**PLN22-182, 1620 Crestview Drive, Los Altos APN 331-11-113**

## **Comment Response Letter**

**Project Name:** 1620 Crestview Drive, Los Altos  
**File Number:** **PLN22-182 (APN: 331-11-113)**  
**Review Cycle:** BSA & GA review dated 11/01/2022

## RESPONSE TO COMMENTS:

PROPOSED FLOOR AREA DIAGRAM  
1620 CRESTVIEW DR  
LOS ALTOS □ CALIFORNIA

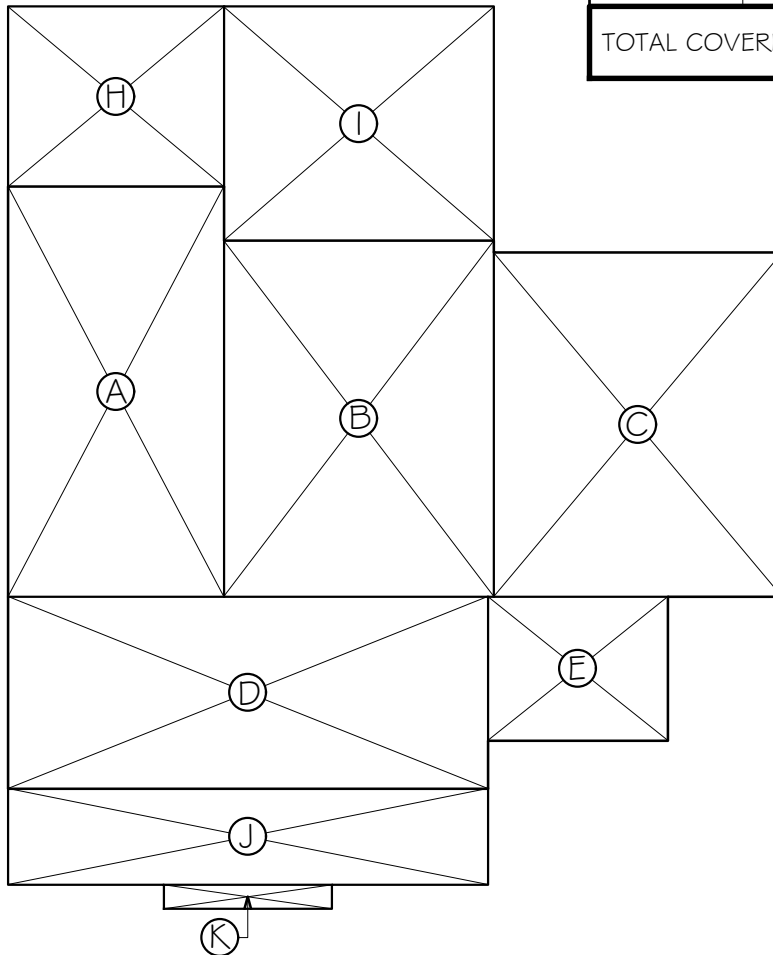
1. The exterior elevations have been added to the plan set, including the overall height.
2. The floor plans have been added to the plan set.
3.
  - a. The buildings are dimensioned on the floor plans.
  - b. The floor area block diagram is attached.
4. The paving in the front setback area has been reduced to 40% of the total setback area. A diagram has been added to sheet A1 to illustrate the area. The pavement shape is complex, so the area has been determined by the AutoCad program instead of trying to show the substantial mathematical analysis of the area.
5. The Grant Deed and Title Report showing legal lot status are attached.
